# HISTORIC AND DESIGN REVIEW COMMISSION

June 18, 2025

**HDRC CASE NO:** 2025-151  
**COMMON NAME:** 1702 BROADWAY  
**ADDRESS:** 1602 BROADWAY  
1606 N ALAMO  
1611 N ALAMO  
1613 N ALAMO  
**LEGAL DESCRIPTION:** NCB 1765 (BESA), LOT 21  
NCB 965 BLK LOT 22, 23 & 24 NCB 984 BLK LOT 33, 34 & 35  
**ZONING:** IDZ-3, H  
**CITY COUNCIL DIST.:** 2  
**APPLICANT:** Mark Henderson/Ford Powell and Carson  
**OWNER:** BESA LAND PARTNERS LP  
**TYPE OF WORK:** Construction of a mixed-use development, relocation of a historic structure  
**APPLICATION RECEIVED:** May 30, 2025  
**60-DAY REVIEW:** July 29, 2025  
**CASE MANAGER:** Edward Hall

The applicant is requesting a Certificate of Appropriateness for approval to:

# Phase I • Landscape Plans

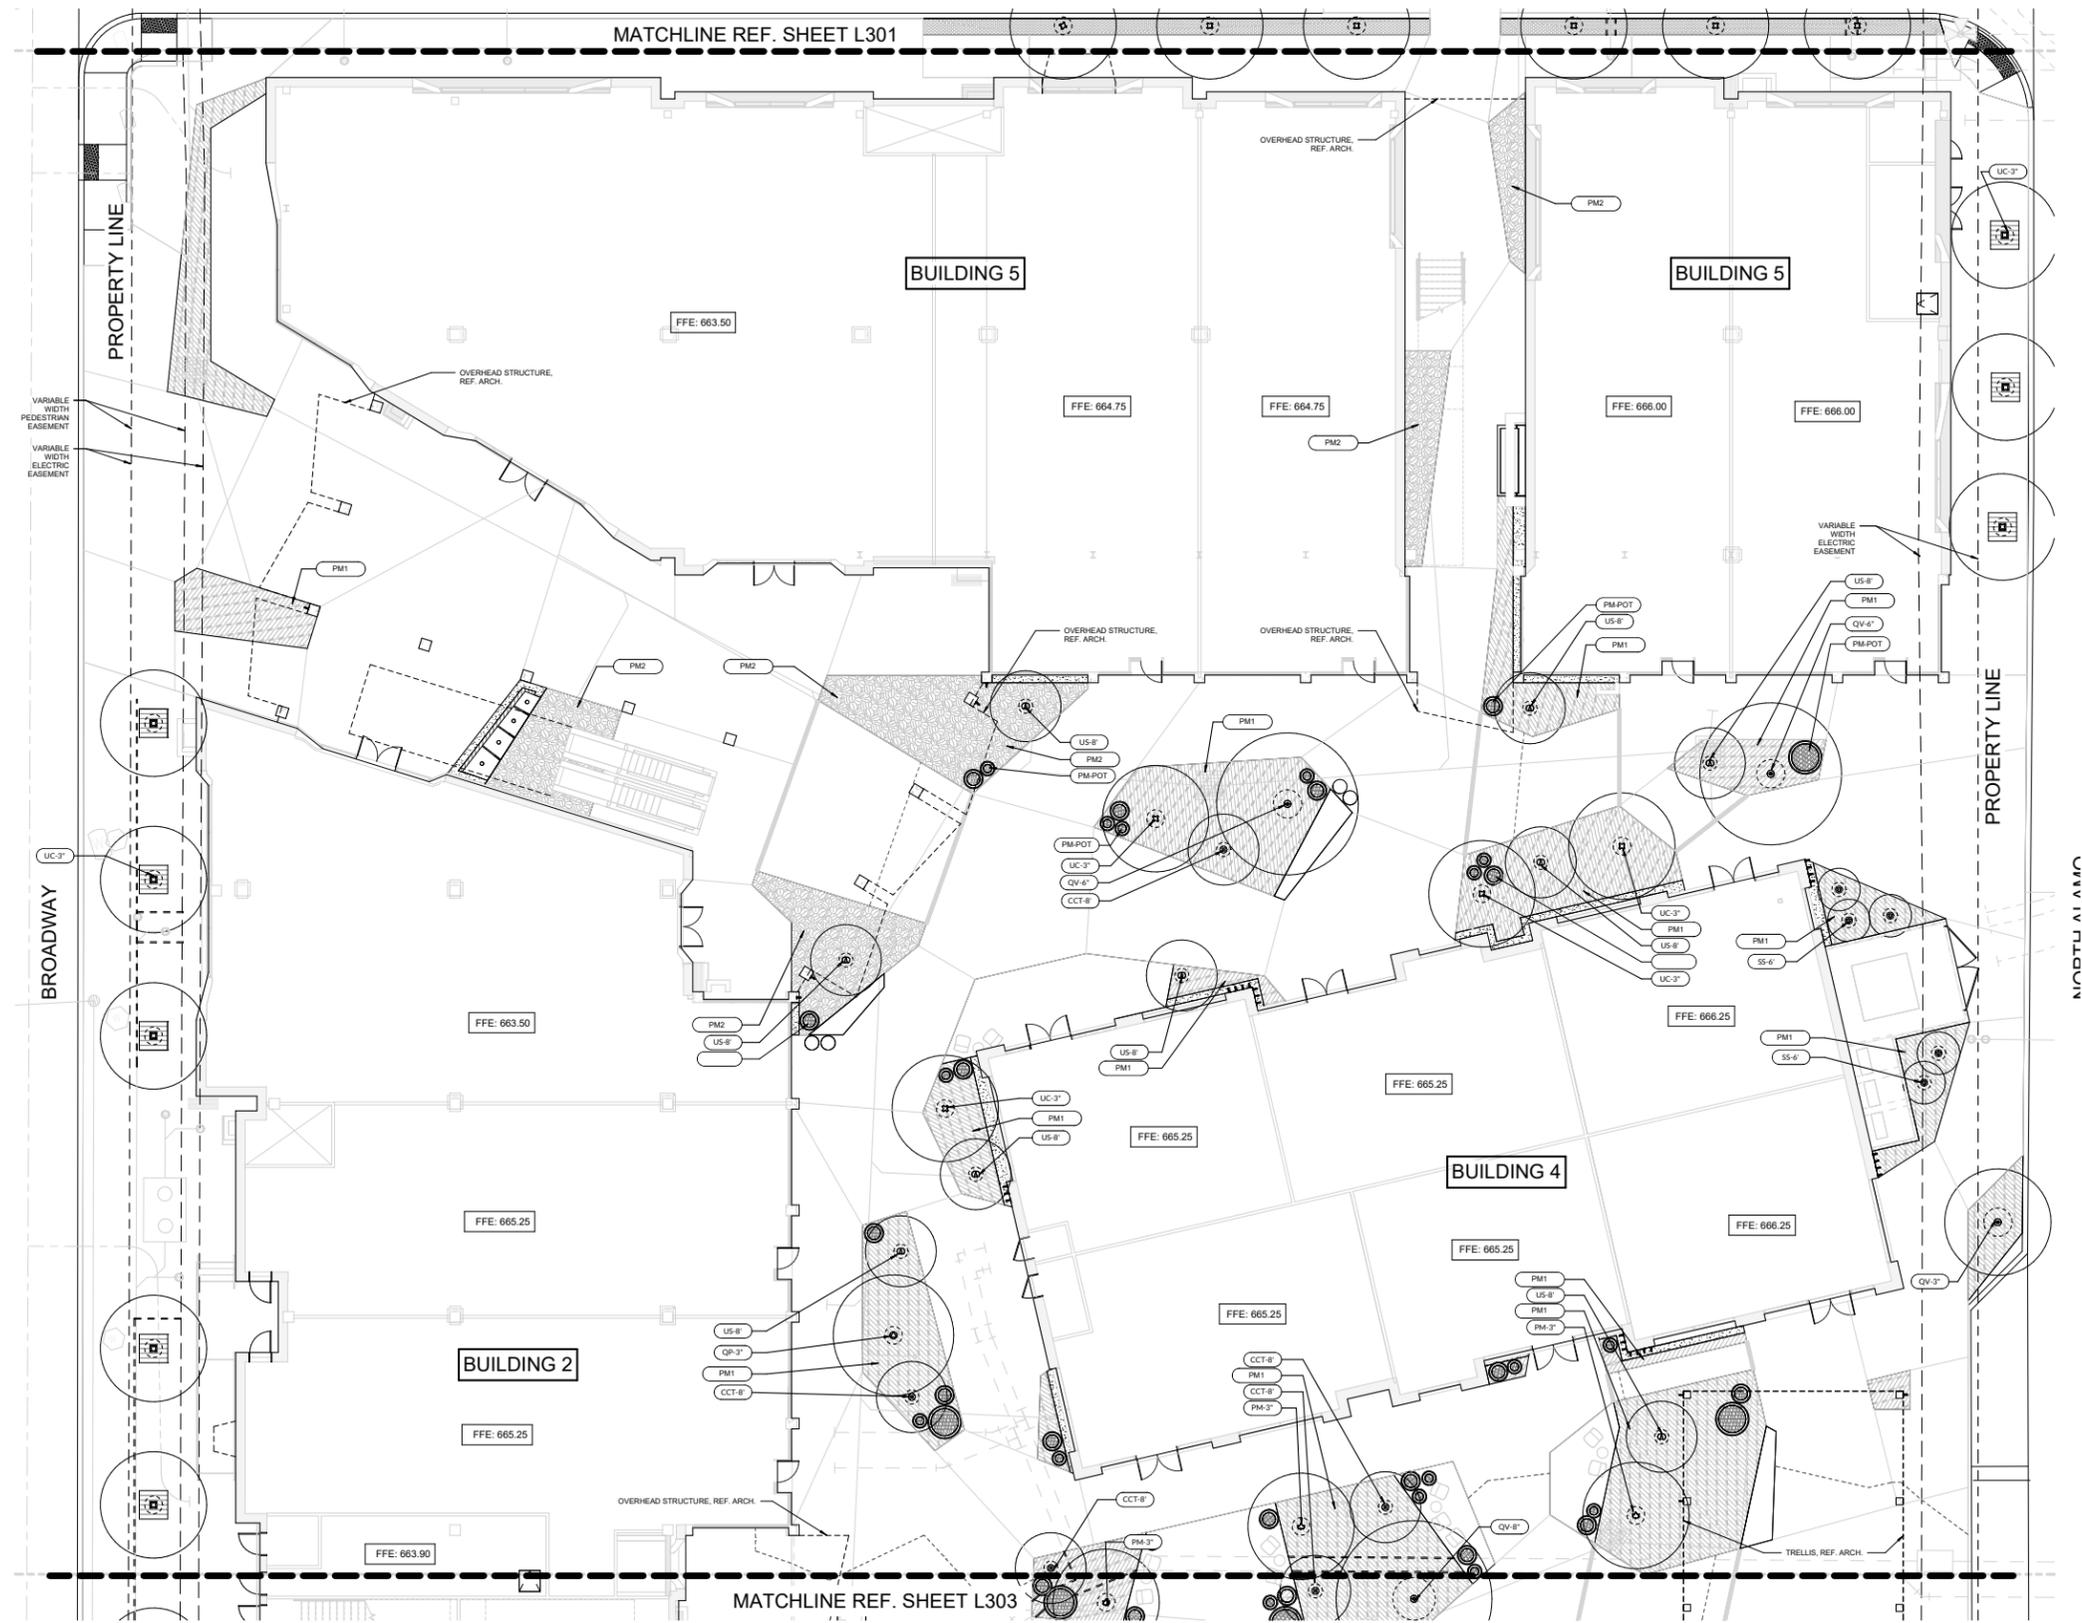
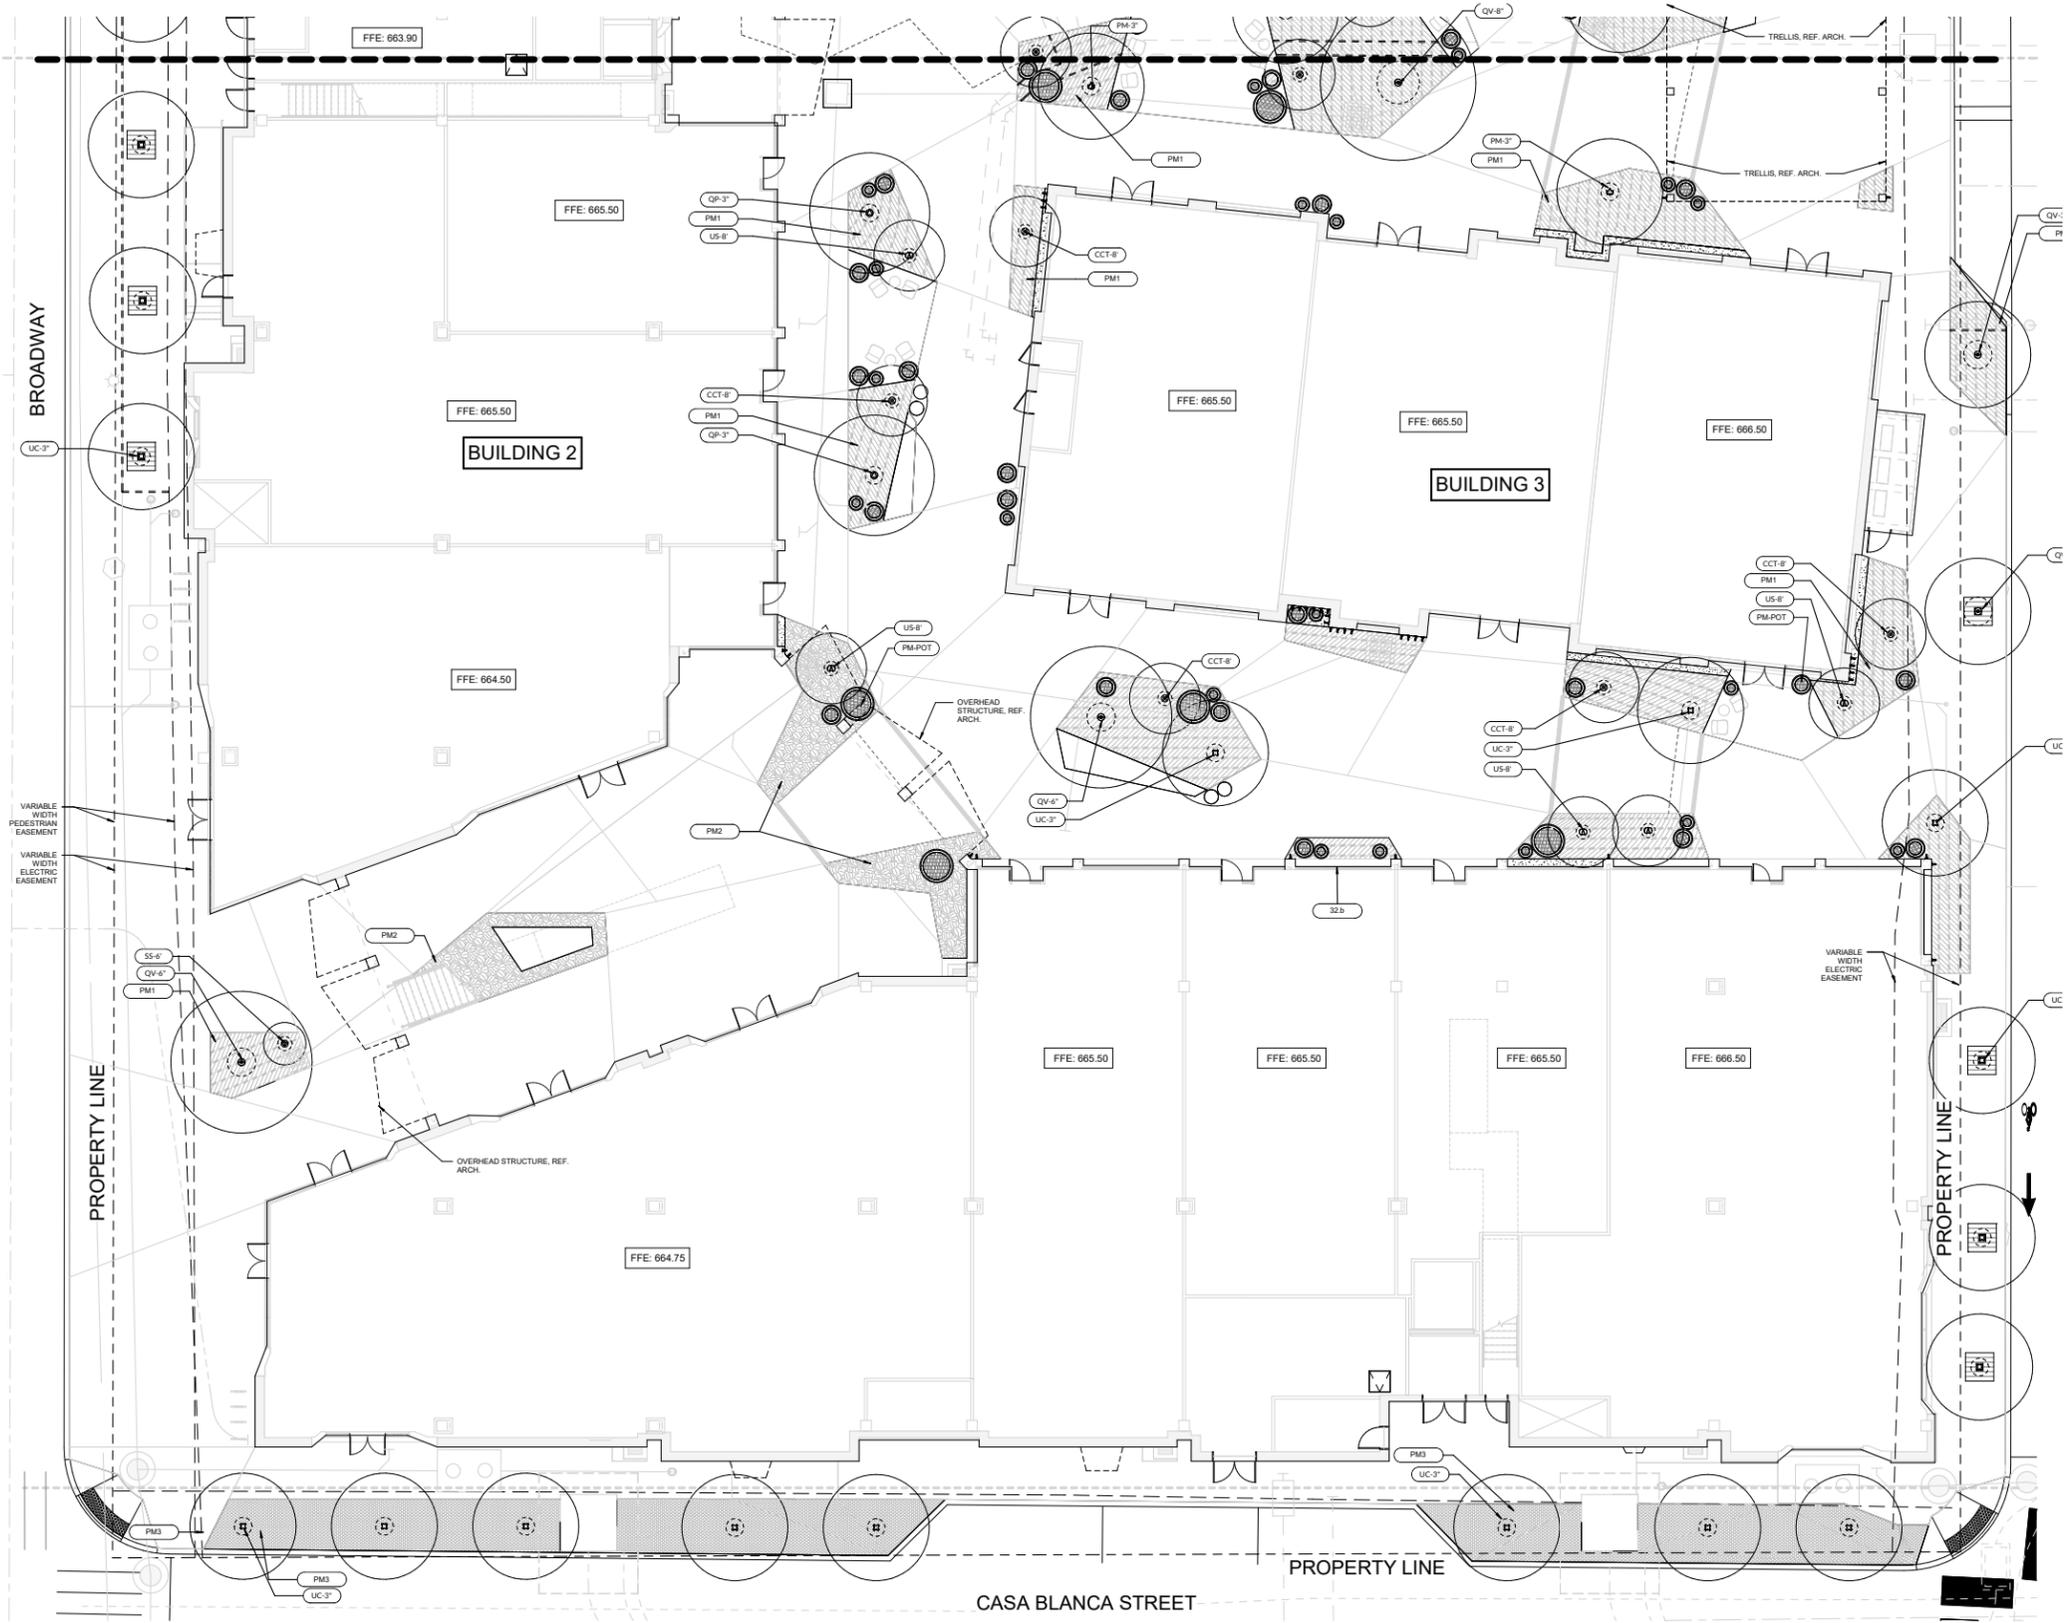
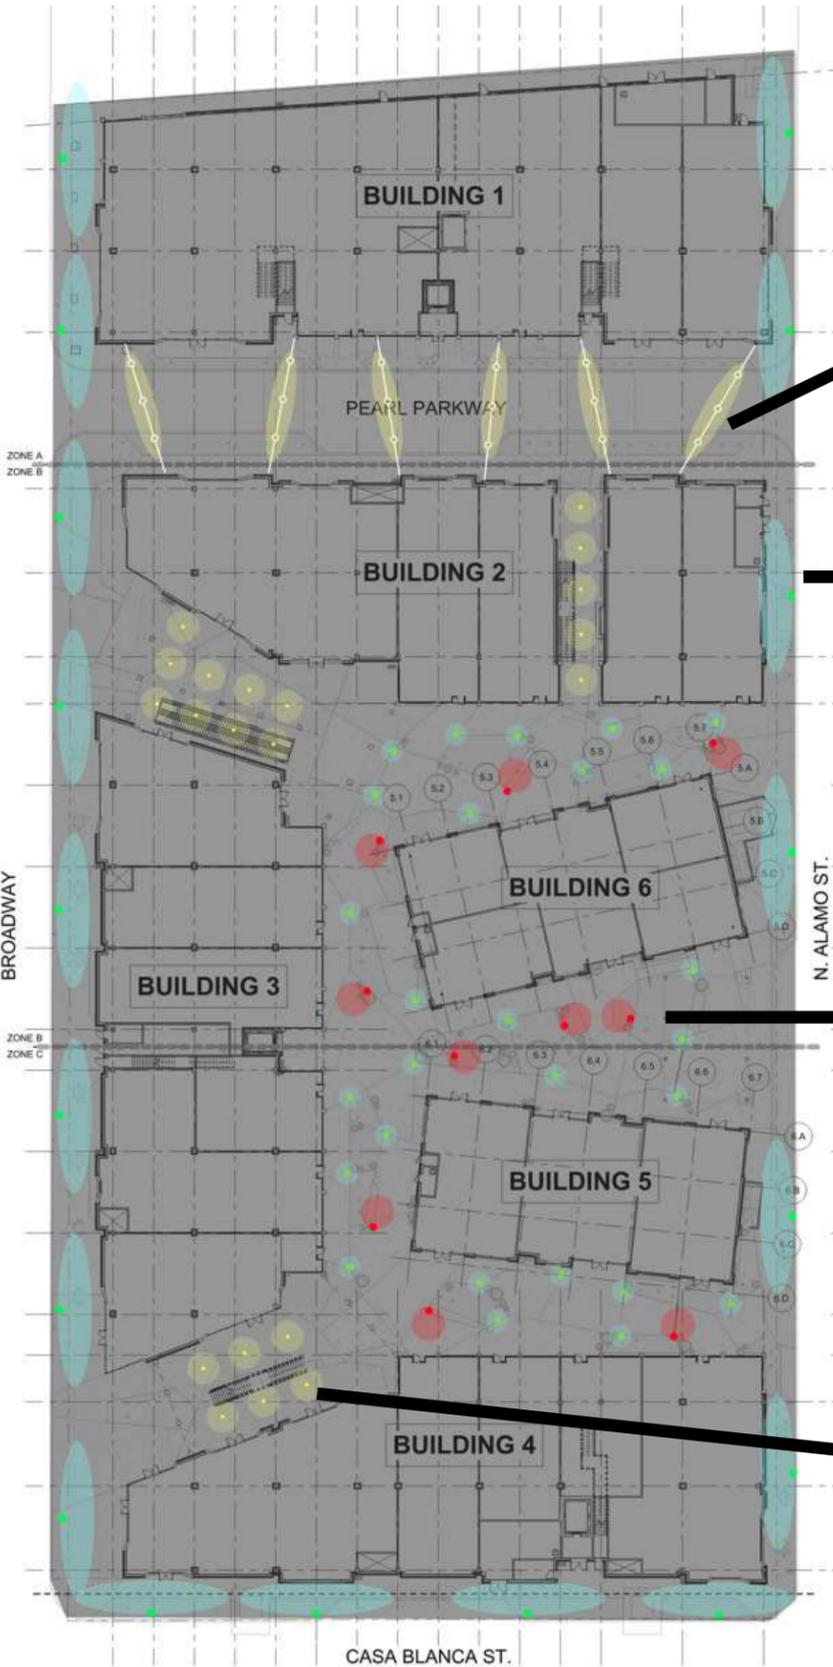
- h. LANDSCAPE DESIGN – Per the UDC Section 35-673(e) regarding landscape design, a variety in landscape design must be provided with no more than seventy-five (75) percent of the landscape materials, including plants being the same as those on adjacent properties. Additionally, according to the UDC Section 35-674(f), indigenous, non-invasive plant species and tropical plant species are permitted. The applicant has submitted a detailed landscaping plan noting the location of various landscaping elements. Staff finds the submitted landscaping plan to be appropriate and consistent with the UDC.

- ii. That a detailed landscaping plan should be developed and submitted for review and approval prior to returning to the Commission for final approval. ***This stipulation has been met.***
